Proposal for Supplement 2 to the 01 series of amendments to UN Regulation No. 135 (Pole Side Impact (PSI))

Submitted by the experts from the Working Party on Passive Safety*

Supplement 2 to the 01 series of amendments to UN Regulation No. 135 (Pole Side Impact (PSI))

Figure

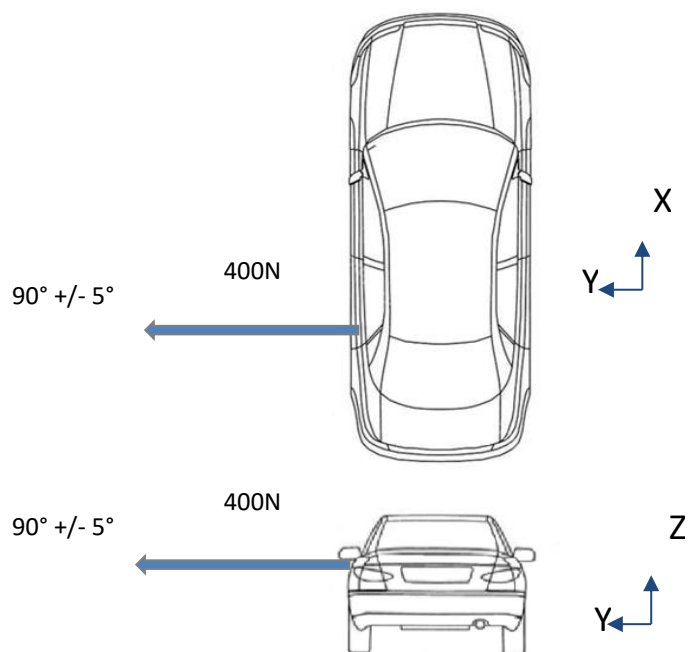
Paragraph 5.4.2.1, amend to read:

- "5.4.2.1. The door shall remain latched;
This requirement is deemed to be fulfilled:
- (a) if it is clearly visible, that the door lock is latched; or
 - (b) if the door does not open under a static tractive force of at least 400 N in the y-direction applied to the door, according to the Figure below, as close as possible to the window sill and to the edge of the door opposite to the hinged side, except to the door handle itself.
